Final Environmental Impact Report (Final EIR)

Los Angeles International Airport (LAX) Bradley West Project

Responses to Comments and Corrections and Additions to the Draft EIR

September 2009

Figure 4.2-4b

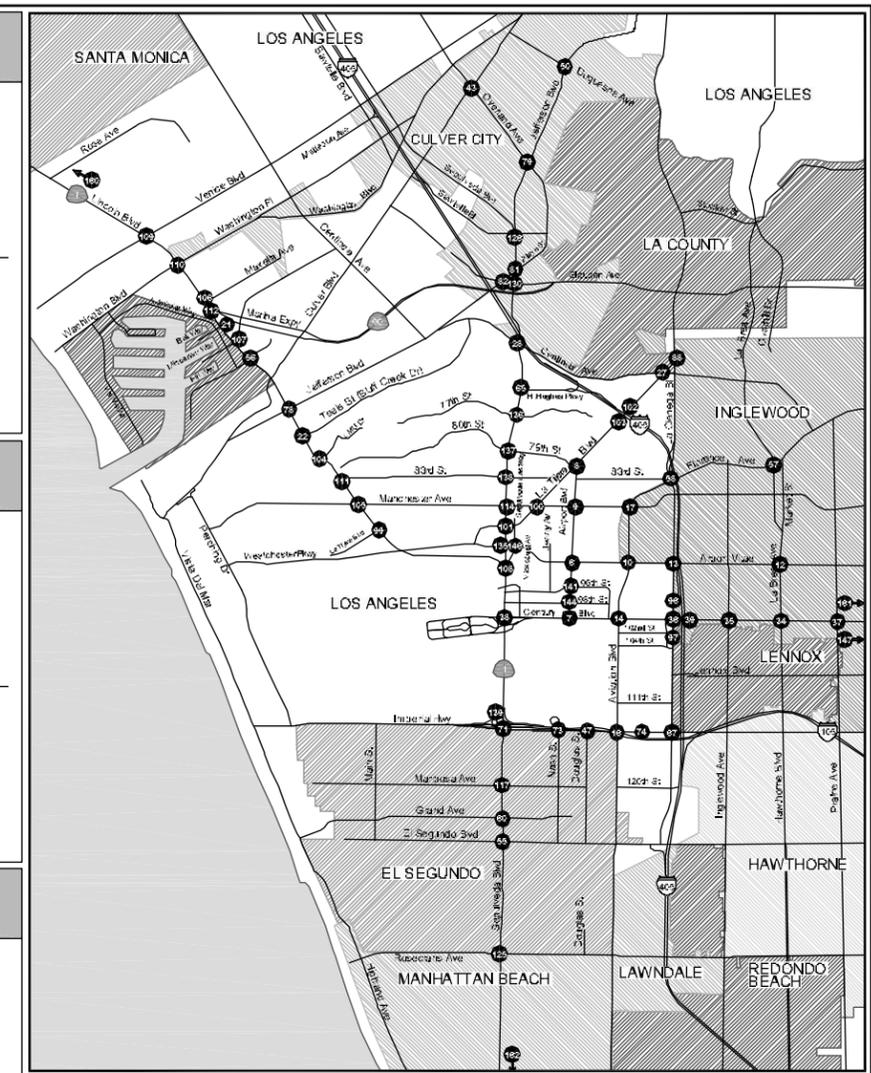
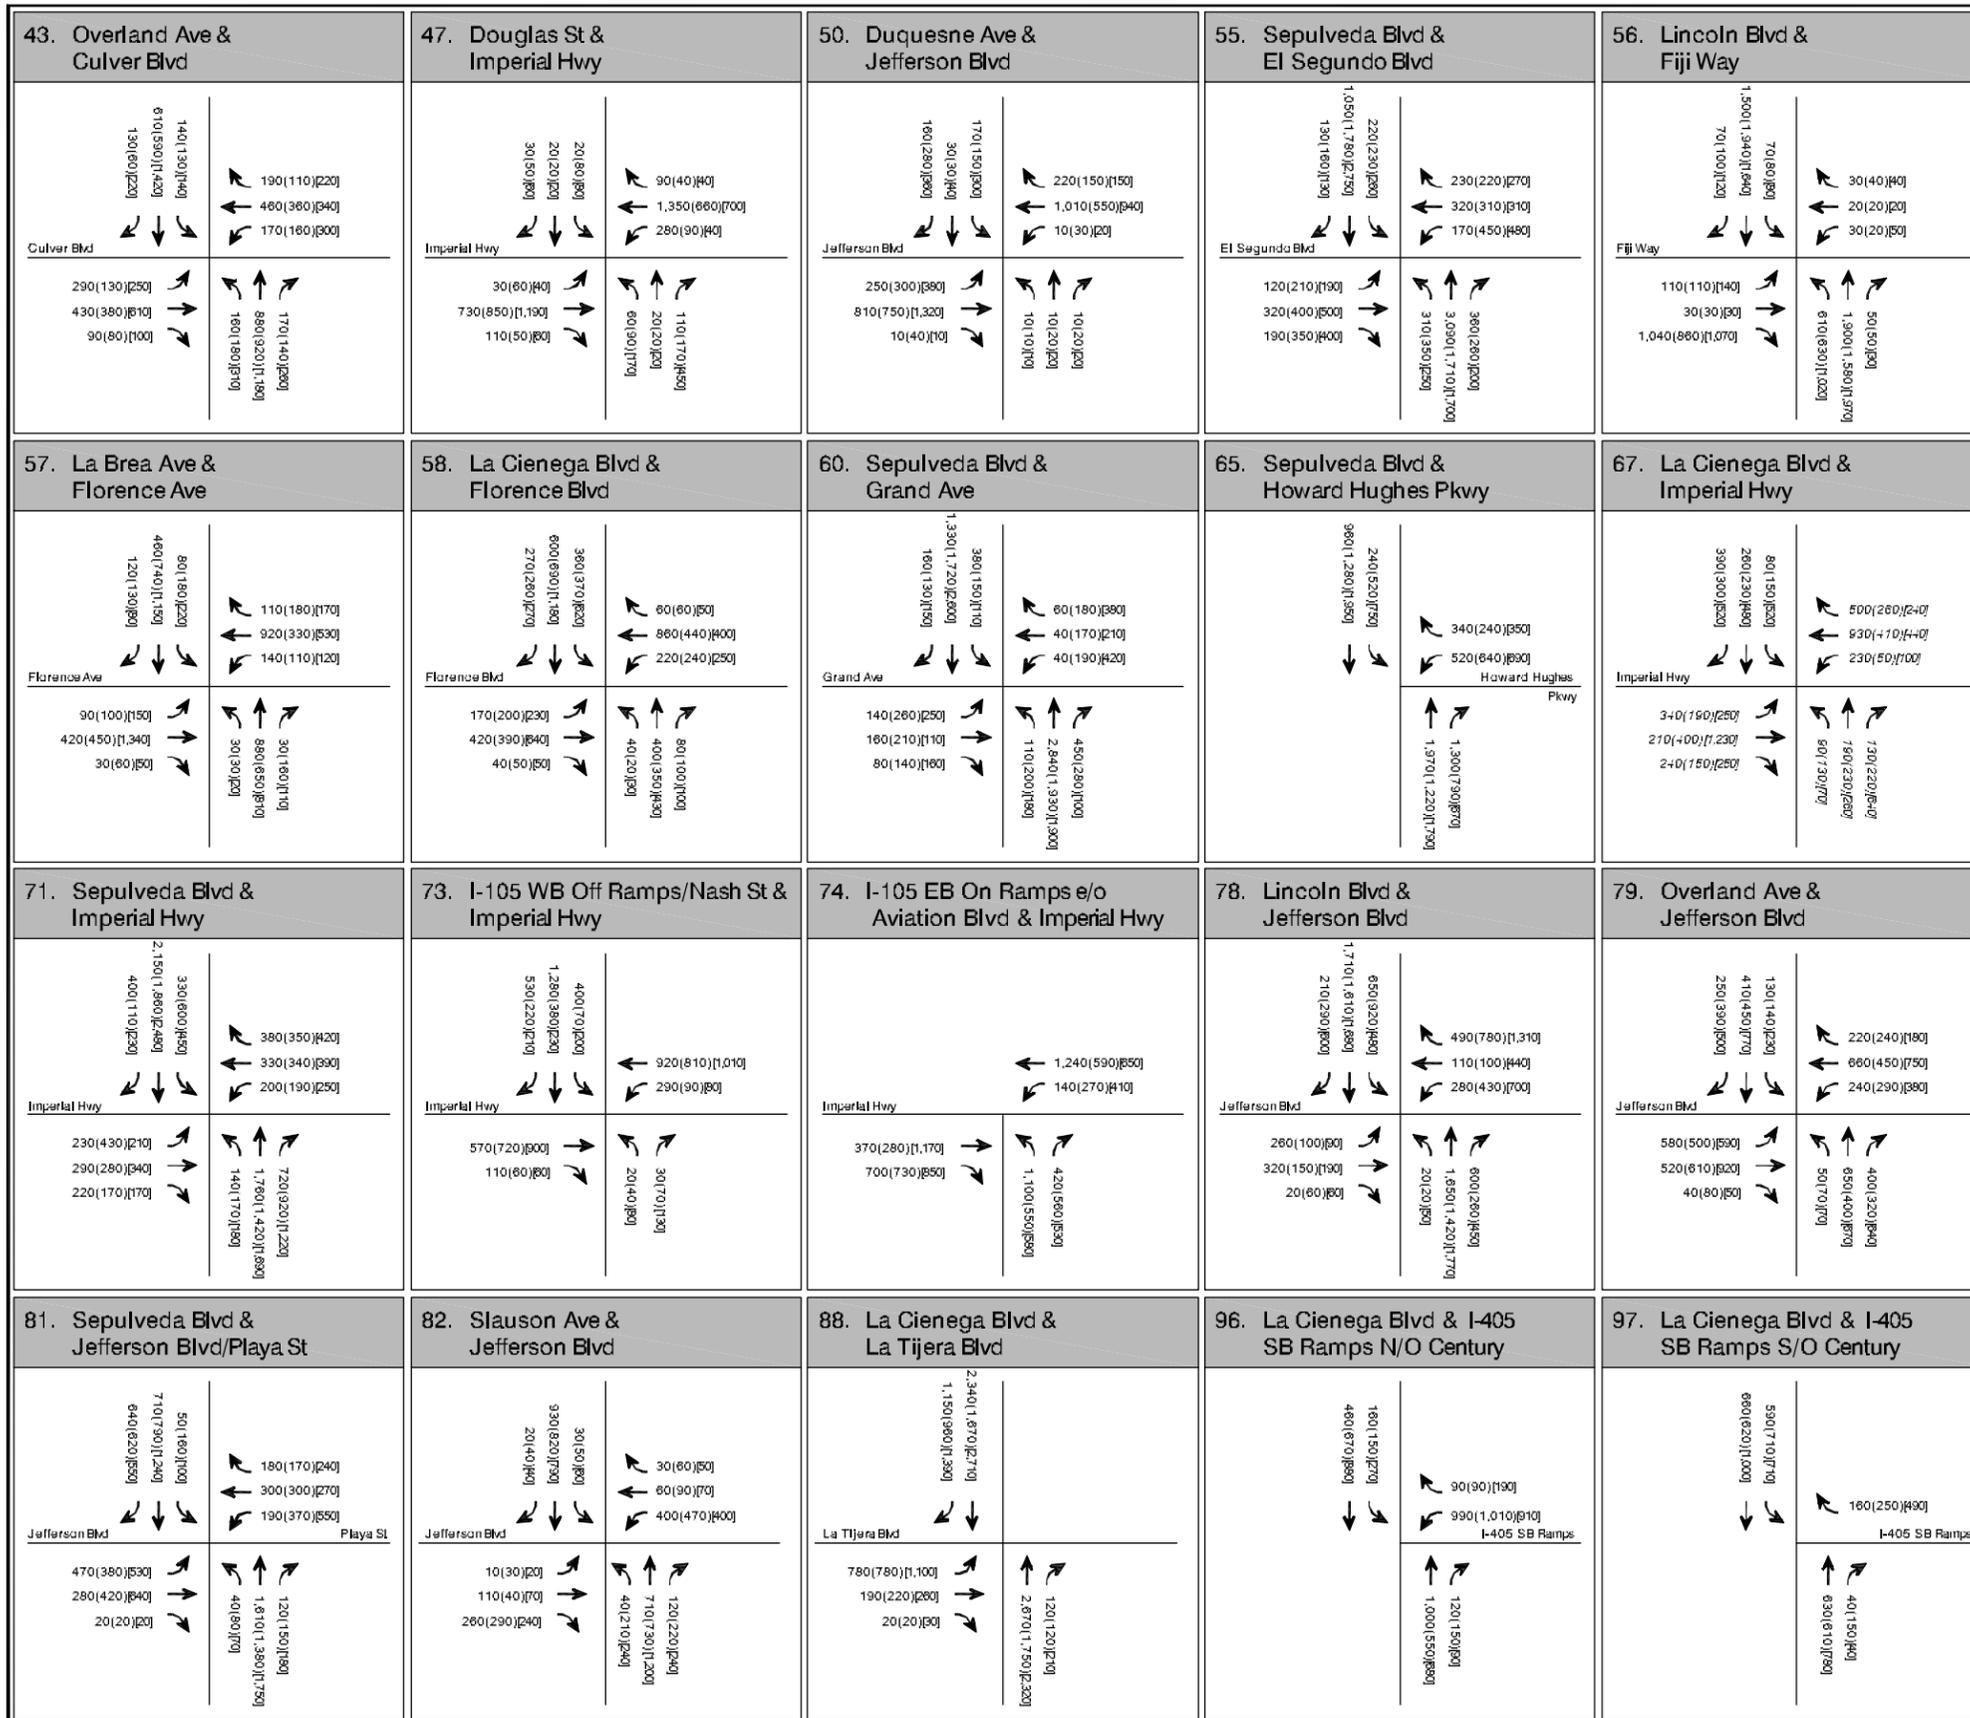
Comment: Volume 4, Appendix C-5, page 4, La Cienega Boulevard and Imperial Highway (Intersection # 67): The AM peak vehicle counts for Existing Conditions do not match those shown in Volume 1 (Main Document), Figure 4.2-3b; similar errors occur with the Mid-day and PM peak vehicle counts. All intersection capacity analysis effected by these errors should be revised accordingly and corresponding mitigation measures and potential improvements should be identified and evaluated for any anticipated significant impacts. If similar errors occur for other project scenarios (e.g. "No Project," "Plus Project" etc.) then capacity analysis calculations and any resulting potential mitigation measures should be also revised accordingly.

Response: The typographical error is noted. In response, Figure 4.2-3b on page 4-105, Figure 4.2-4b on page 4-139, and Figure 4.2-5b on page 4-147 of the Bradley West Project Draft EIR have been revised. Please see Chapter 3, Corrections and Additions to the Bradley West Project Draft EIR. The intersection capacity analyses under all scenarios are not affected by this typographical error as it only occurred in the figures. The correct values were used in the LOS calculations and hence no revisions to the LOS calculations are required.

Figure 4.2-4c

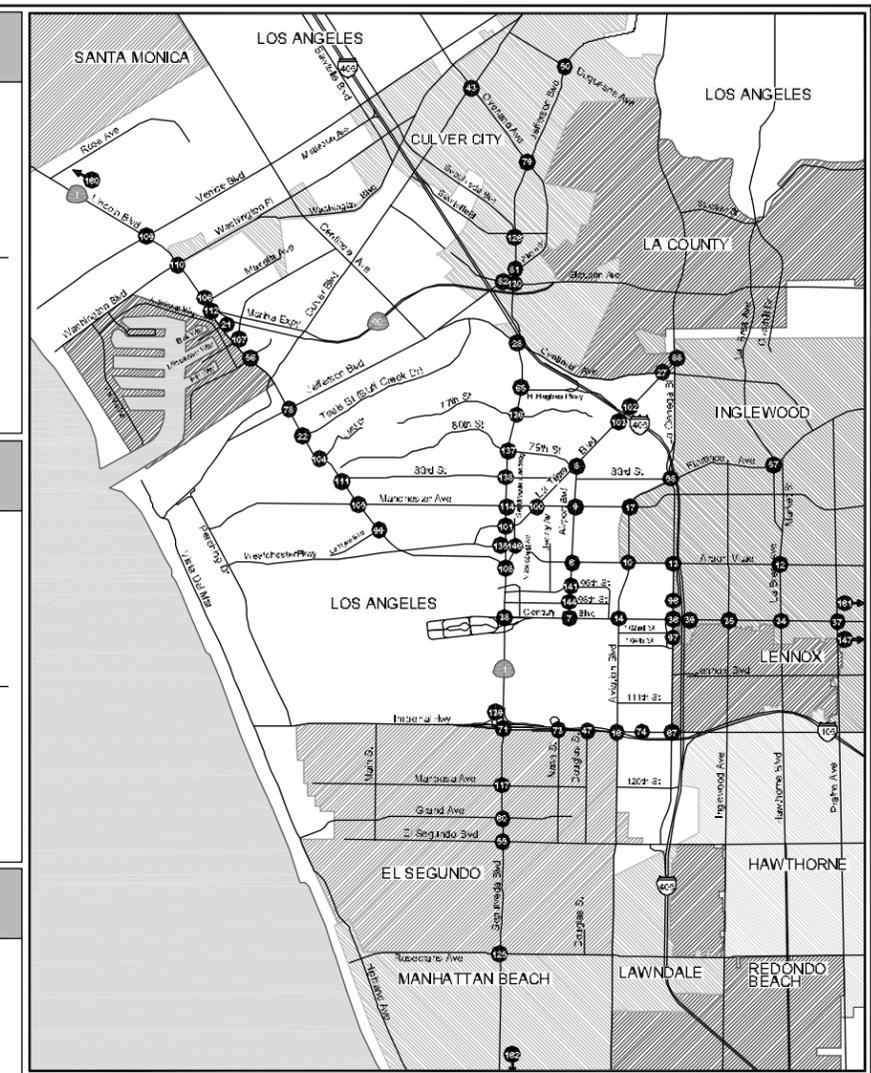
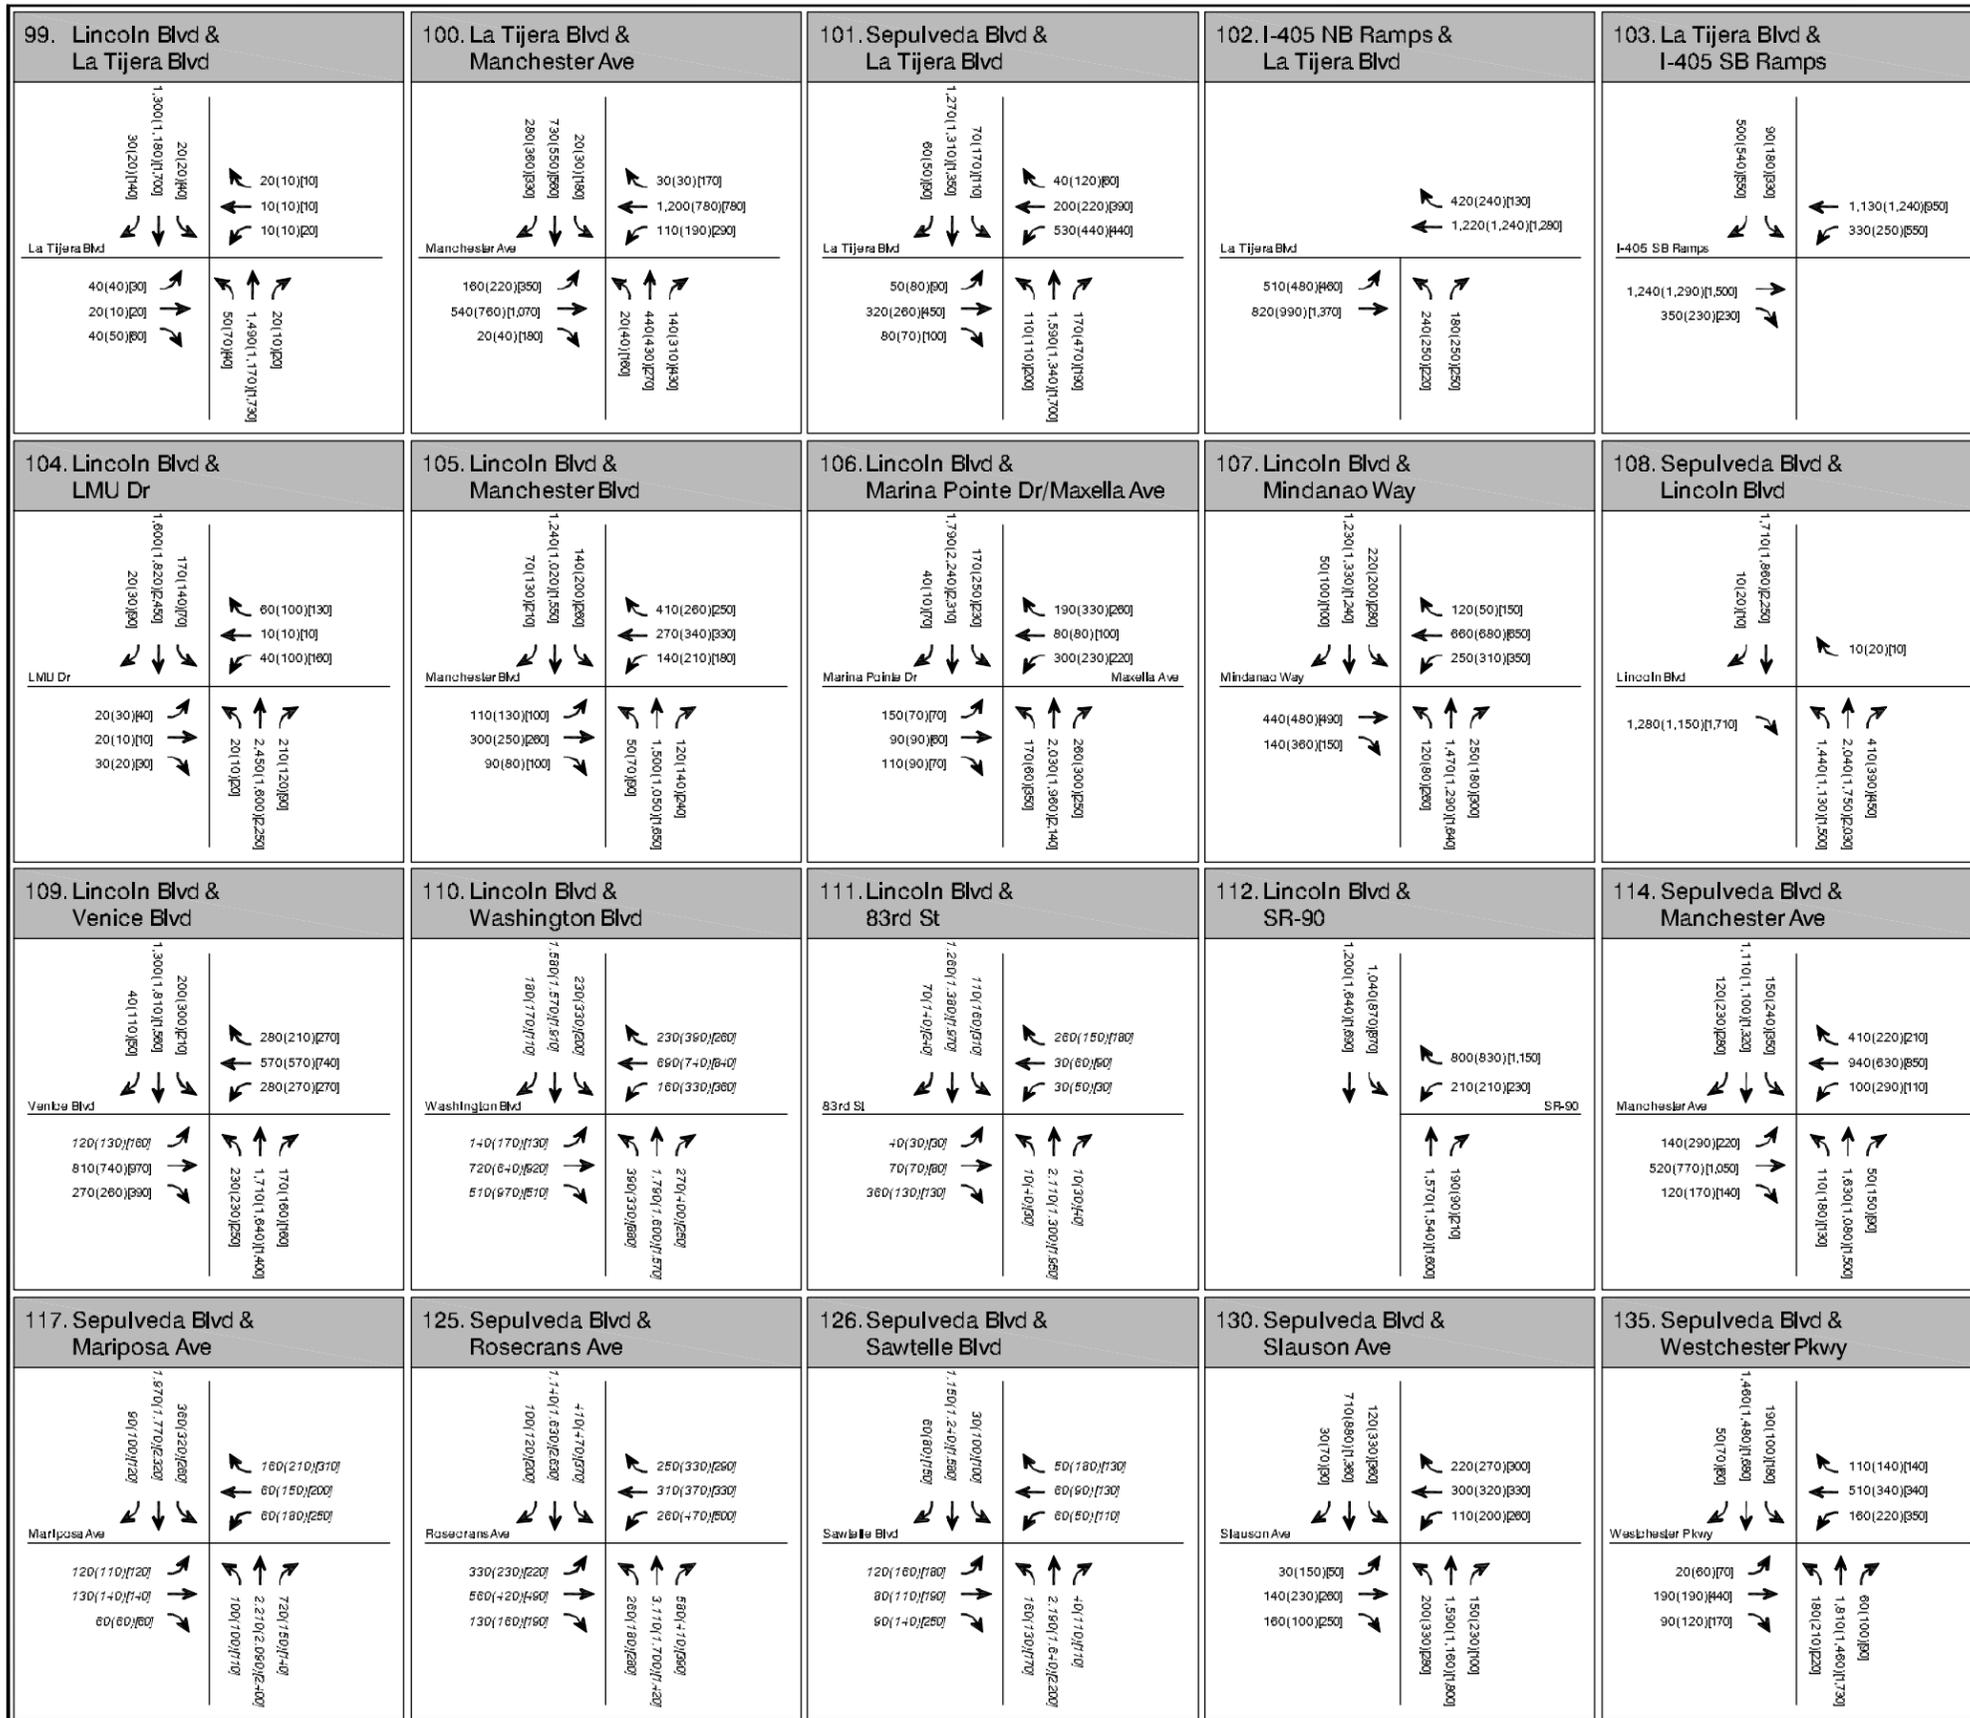
Comment: Volume 4, Appendix C-5, page 9, Lincoln Boulevard and Washington Boulevard (Intersection # 110): The AM peak vehicle counts for Existing Conditions do not match those shown in Volume 1, Figure 4.2-3c; similar errors occur with the Mid-day and PM peak vehicle counts. All intersection capacity analysis effected by these errors should be revised accordingly and corresponding mitigation measures and potential improvements should be identified and evaluated for any anticipated significant impacts. If similar errors occur for other project scenarios (e.g. "No Project," "Plus Project" etc.) then capacity analysis calculations and any resulting potential mitigation measures should also be revised accordingly.

Comment: Volume 4, Appendix C-5, page 9, Lincoln Boulevard and 83rd Street (Intersection #111): The AM peak vehicle counts for Existing Conditions do not match those shown in Volume 1, Figure 4.2-3c; similar errors occur with the Mid-day and PM peak vehicle counts. All intersection capacity analysis effected by these errors should be revised accordingly and corresponding mitigation measures and potential improvements should be identified and evaluated for any anticipated significant impacts. If similar errors occur for other project scenarios (e.g. "No Project," "Plus Project" etc.) then capacity analysis calculations and any resulting potential mitigation measures should also be revised accordingly.

Response: The typographical error is noted. In response, the volume figure for the Lincoln Boulevard and Washington Boulevard intersection in Figure 4.2-3c on page 4-107, Figure 4.2-4c on page 4-141, and Figure 4.2-5c on page 4-149 of the Bradley West Project Draft EIR has been revised. Please see Chapter 3, Corrections and Additions to the Bradley West Project Draft EIR. However, the revised Mid-day southbound through volume at the Lincoln Boulevard and Washington Boulevard intersection does not match the vehicle counts because the volume was adjusted to be consistent with the traffic volumes at nearby intersections. As stated on page 4-90 in Section 4.2 of the Bradley West Project Draft EIR, traffic volumes, counted or forecasted, are balanced to ensure a reasonable amount of vehicles are either gained or lost between adjacent intersections. The volumes used in the intersection analysis for all scenarios match the revised volumes for all periods; therefore, the intersection analysis is not affected and no additional revisions are required.

Response: The typographical error is noted. In response, the volume figure for the Lincoln Boulevard and 83rd Street intersection in Figure 4.2-3c on page 4-107, Figure 4.2-4c on page 4-141, and Figure 4.2-5c on page 4-149 of the Bradley West Project Draft EIR has been revised. Please see Chapter 3, Corrections and Additions to the Bradley West Project Draft EIR. However, the revised AM and Mid-day northbound and southbound through volumes at the Lincoln Boulevard and 83rd Street intersection do not match the vehicle counts because the volume was adjusted to be consistent with the traffic volumes at nearby intersections. As stated on page 4-90 in Section 4.2 of the Bradley West Project Draft EIR, traffic volumes, counted or forecasted, are balanced to ensure a reasonable amount of vehicles are either gained or lost between adjacent intersections. The volumes used in the intersection analysis for all scenarios match the revised volumes for all periods; therefore, the intersection analysis is not affected and no additional revisions are required.
